CENTRAL VALLEY REGIONAL WATER QUALITY CONTROL BOARD

INSPECTION REPORT

LOCATION & COUNTY: Henry Tosta Dairy
[REDACTED], Tracy
San Joaquin County

INSPECTION DATE: 1 May 2012

Map 1: Satellite image of the Henry Tosta Dairy depicting the location of features described in the inspection report.

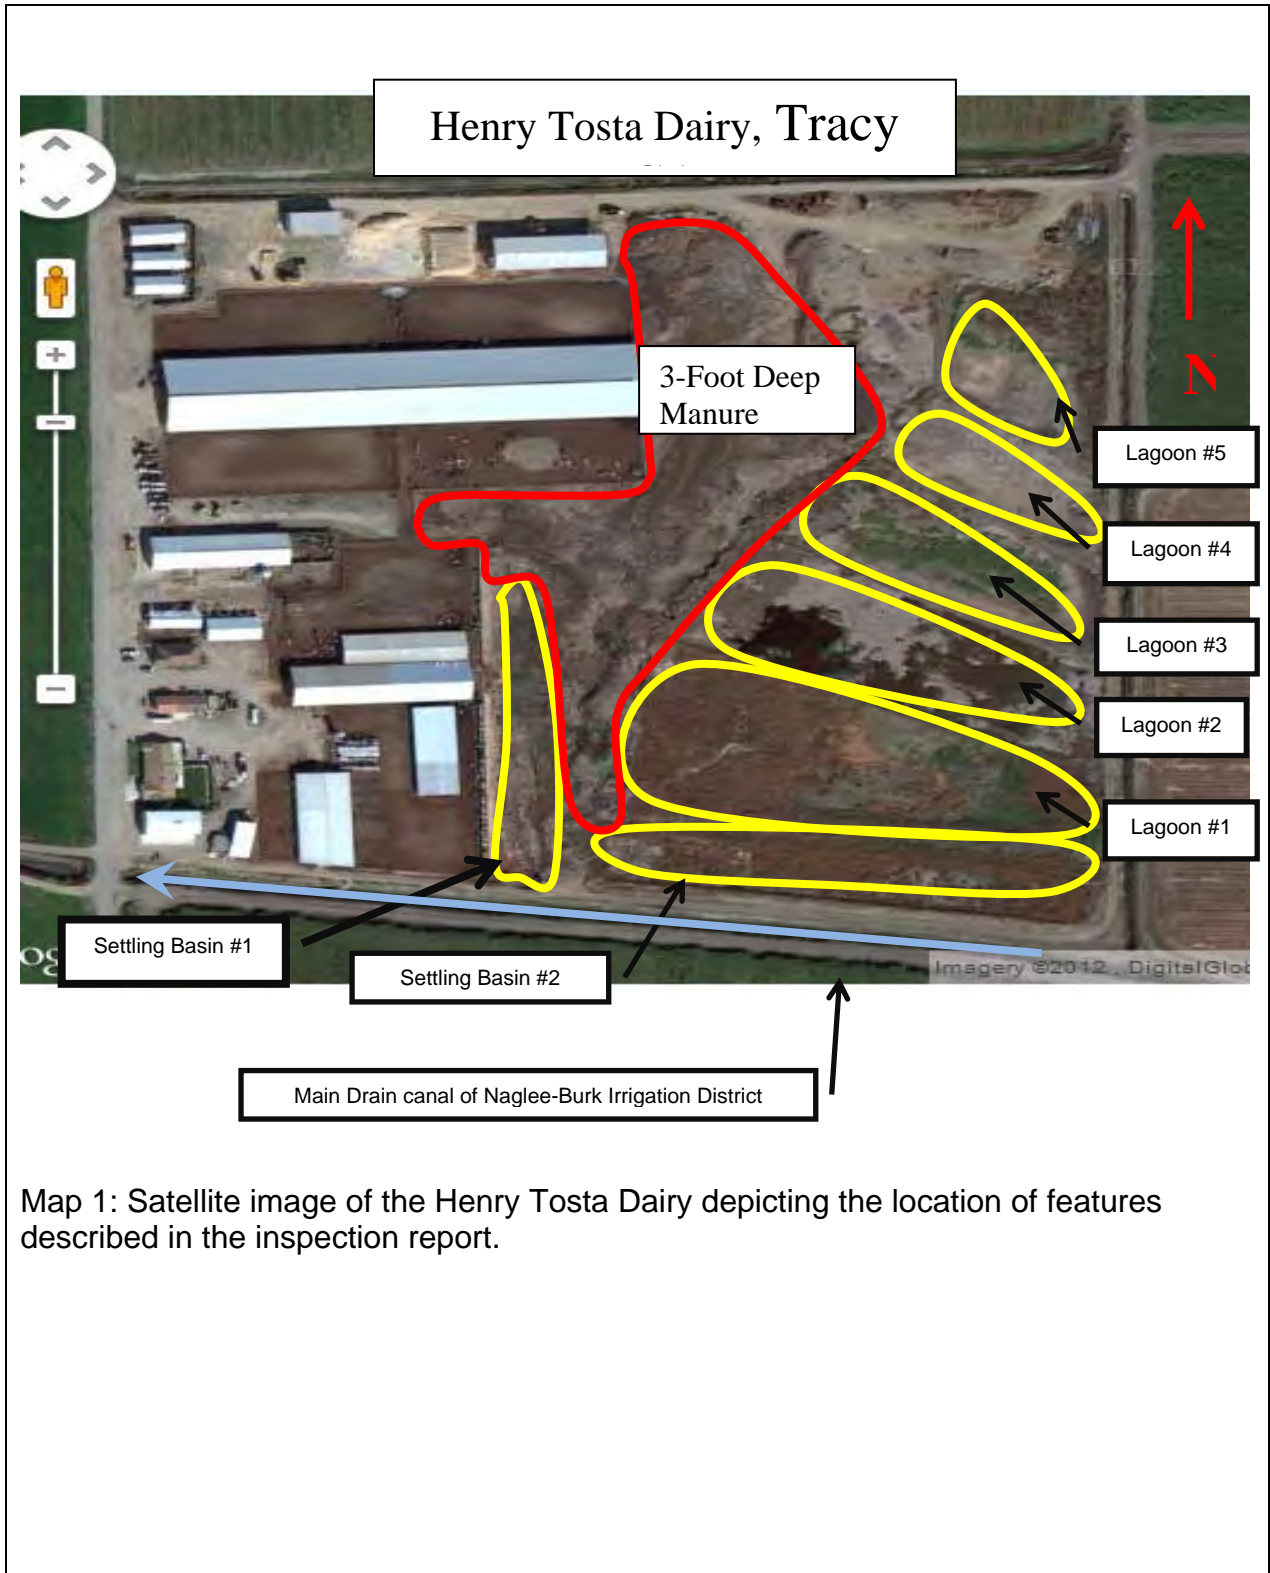
Regional Water Quality Control Board staff (staff) conducted a routine compliance inspection at the Henry Tosta Dairy on 1 May 2012. The dairy is located at [REDACTED] in Tracy. The Henry Tosta Dairy is permitted for 1196 mature cows; the facility houses approximately 1180 mature cows (1051 milking, 140 dry). Map 1 depicts the location of features described in this inspection report.

The complex of wastewater impoundments is being poorly managed and showed no staff gauges, excessive vegetation and manure on and adjacent to the embankments, solid manure being used to reinforce embankments at Settling Basin #2, no definition between any of the impoundments, and a PVC pipe connecting Settling Basin #1 to the Main Drain canal of Naglee-Burk Irrigation District (Photo 5). Additionally, it was difficult for staff to determine the lagoon dimensions and embankment integrity of select lagoons due to the amount of solid manure and weeds located on the impoundment embankments (Photo 8,9,11, and 12). Mr. Tosta stated the lagoons were cleaned out approximately 6-7 years ago. No method to move wastewater between the settling basins and lagoons could be observed during the inspection with the exception of the southern settling basin; this basin can transfer wastewater to the wastewater storage lagoon via a loosely defined earthen channel.

Immediately west of Settling Basin #2 and Lagoons #1-5 is an area of native soil that is used to store liquid wastewater, solid manure, and slurry manure. This area has not been prepared or designed to store waste, and is not contained or graded to prevent ponding of wastewater. Staff estimates this area to be approximately 3-4 acres with manure one to three feet deep in places (Photos 18-26).

Select corrals contained excessive manure and ponding of wastewater (Photos 28-29). The excessive manure and ponding of wastewater is due to the 3-4 acre slurry area backing up into the corral. The remainders of the corrals were well-graded with all run-off ultimately discharging to Settling Basin #1.

- 1) Modify Waste Management Plan to reflect actual on-site conditions in the production area, including the use of the area where slurry is deposited.

- 8) Remove all wastewater, solid manure, and slurry manure from the area located west of the wastewater storage lagoons and northeast of Settling Basin #1 (Photos 18-26). This area must be scraped to native soil. All manure should be exported off-site or otherwise managed to mitigate the impact. Provide documentation regarding the amount of manure removed and the destination of the manure. Groundwater samples should be obtained from the above mentioned area after the manure is removed.
